Access Compliance Report

Public Rights-of-Way

Intersection ID: 4101	Main Street: N_TRYON_ST	Cross Street: WEDNESBURY_BV	Location: NW
ADA ID: A5D2B310C7C0	Ramp Type: Directional1	Initial Pass/Fail: Fail	Overall Compliance: No
Severity Score: 46.25			
Codes/Mitigation Info/Possible Solution		Field Measurements/Component Compliance

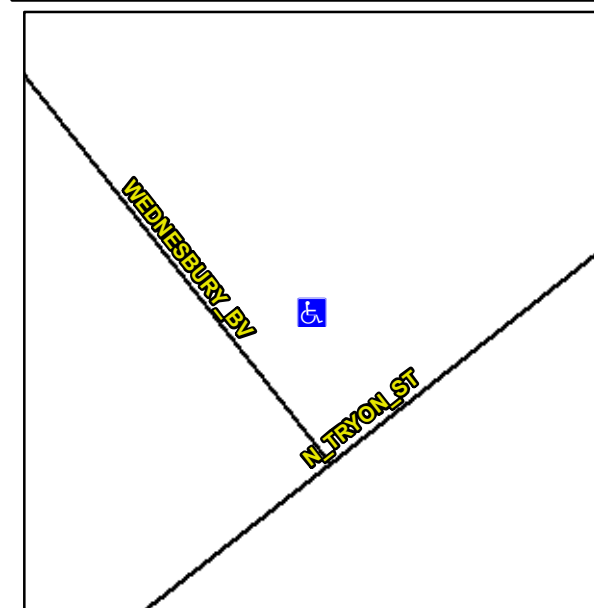
R304.5.1, R304.2.2, R304.5.3

Compliance	Description	Data	Compliance	Description	Data
N/A	Ramp Length (in)	106.0	N/A	Grade Break?	N/A
No	Ramp Width (in)	41.0	N/A	Grade Break Slope (%)	0.0
No	Ramp Slope (%)	24.7	N/A	Grade Break XSlope (%)	0.0
No	Ramp XSlope (%)	5.8			
N/A	Flare Type LT	N/A	N/A	Flare Type RT	N/A
N/A	Flare Slope LT (%)	N/A	N/A	Flare Slope RT (%)	0.0
N/A	Flare Traversable LT?	N/A	N/A	Flare Traversable RT?	N/A
N/A	Landing Length (in)	0.0	N/A	DWS Provided?	N/A
N/A	Landing Width (in)	0.0	N/A	DWS Contrast?	N/A
N/A	Landing Slope (%)	0.0	N/A	DWS Length (in)	N/A
N/A	Landing X Slope (%)	0.0	N/A	DWS Full Width?	N/A
N/A	Landing Curb? (Y/N)	N/A	N/A	DWS Offset LT (in)	N/A
N/A	Shared Landing?	N/A	N/A	DWS Offset RT (in)	N/A
N/A	Gutter Ponding?	0.0	N/A	Gutter Slope (%)	N/A
N/A	Gutter Lip Ht (in)	0.0	N/A	Gutter X Slope (%)	N/A
N/A	Painted X Walk1?	No		Road Slope (%)	1.2
	X Walk 1 Direction	To SW		Road X Slope (%)	8.8
	X Walk 1 Width (in)	N/A		Clear Space?	N/A

Remove & Replace Entire Ramp.
